Supplement to: Commonwealth Edison Submittal of Information Pertaining to Motor Operated Valve Testing as Specified in NRC Generic Letter 89-10 and the Subsequent Supplements to the Generic Letter

Subject: Review of White Paper WP-129, "MOV Design Margin Evaluation and Diagnostic Test Feedback Evaluation"

### **REVIEW REPORT** FOR REVIEW OF COMMONWEALTH EDISON WP-129

Figure 1. MOV Design Margin Calculations

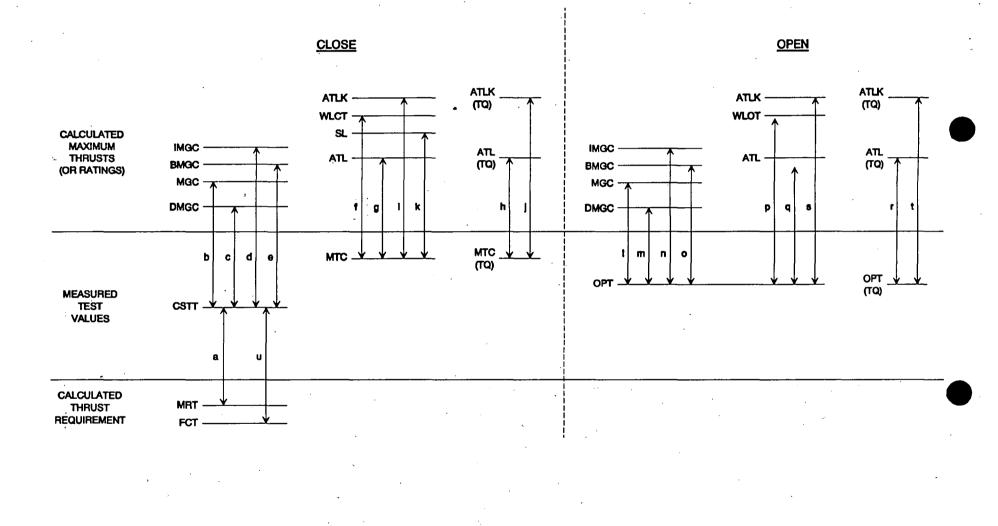
- There are a total of twenty-one different design margin calculations identified in WP-129 (Section 4, items 4a through 4u). It is not clearly stated whether all of these twenty-one calculated design margin values need to satisfy specific criteria for the design margin to be acceptable, or whether (in some cases) only some of the calculated margin values need to meet criteria. The position needs to be clarified.

Figure 1 of this review report illustrates the twenty-one different design margin calculations identified in WP-129. A diagram similar to Figure 1 should be included in the white paper to more clearly illustrate the set of design margin calculations described.

## Figure 1 - MOV Margin and Importance Matrix

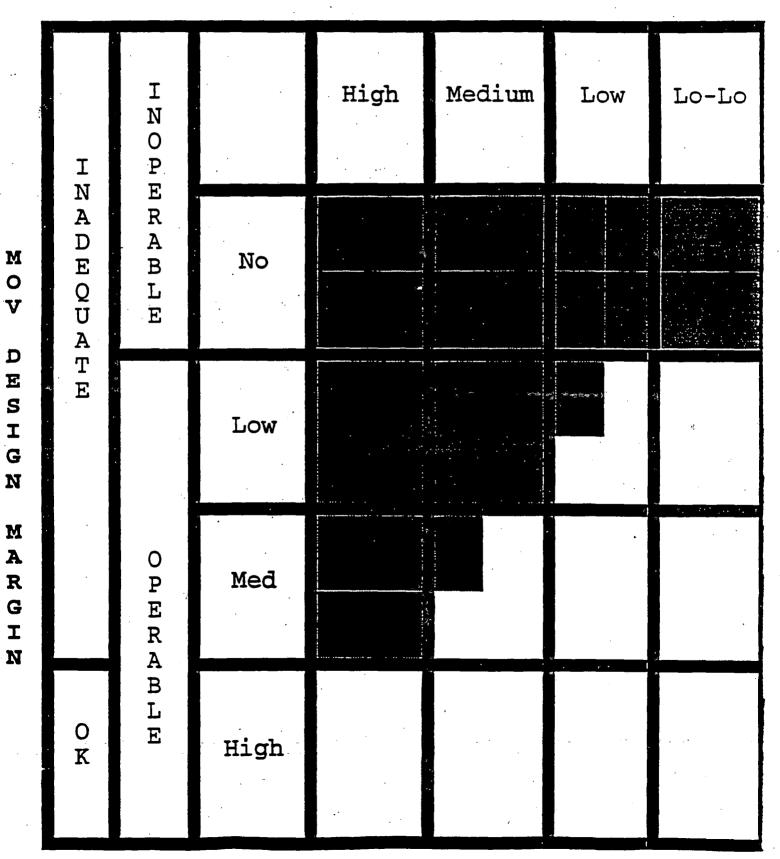
- Figure 1 of WP-129 indicates that a risk-based approach is used for prioritizing the safety importance of each MOV included in the Generic Letter 89-10 scope. However, prioritization of MOVs based on risk importance is not discussed in WP-129. The white paper where this prioritization is justified should be referenced.

- The criteria by which the margin is classified as high, medium, low or none needs to be definitively stated. For example, WP-129 states, "A high margin valve would typically have greater than 35 percent margin to the minimum required thrust and greater than 10 percent margin to the maximum allowable thrust." It is not clear whether the 35 percent and 10 percent values are hard criteria for determining high margin or whether they are simply indicative yardsticks. Our understanding is that these are the criteria for use in WP-129. If so, they should be clearly stated to be the criteria.
